SERVICE CAMPAIGN BULLETIN

CAMPAIGN REF: 02F
TITLE : Parking Sensors Heli-tape Disc Installation
DOCUMENT # : 11 A 049
AFFECTED VEHICLES : McLaren 650S Coupe and Spider

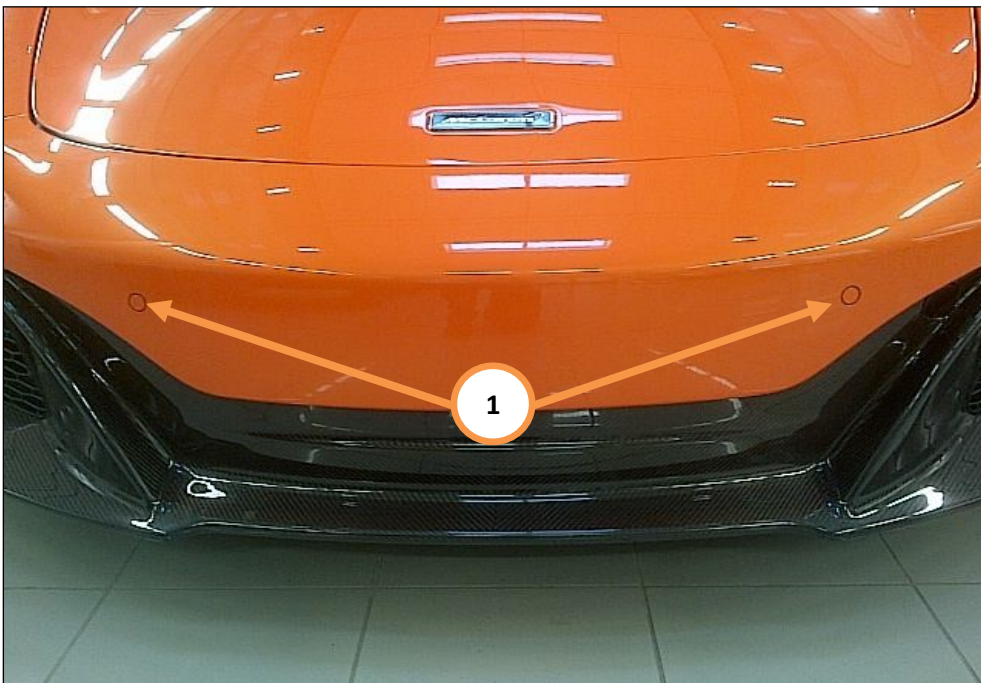
SITUATION : Quality Engineering at McLaren Automotive have identified that the front parking sensor may incorrectly detect an object when nothing is present in front of the vehicle.

1. Clean the surface of the front two centre parking sensors with an alcohol cleaning solution or similar product to remove any dirt and grease (1).

2. Install the heli-tape disc 11A4666CP to the two front centre parking sensors ensuring that you have no air gaps (2).
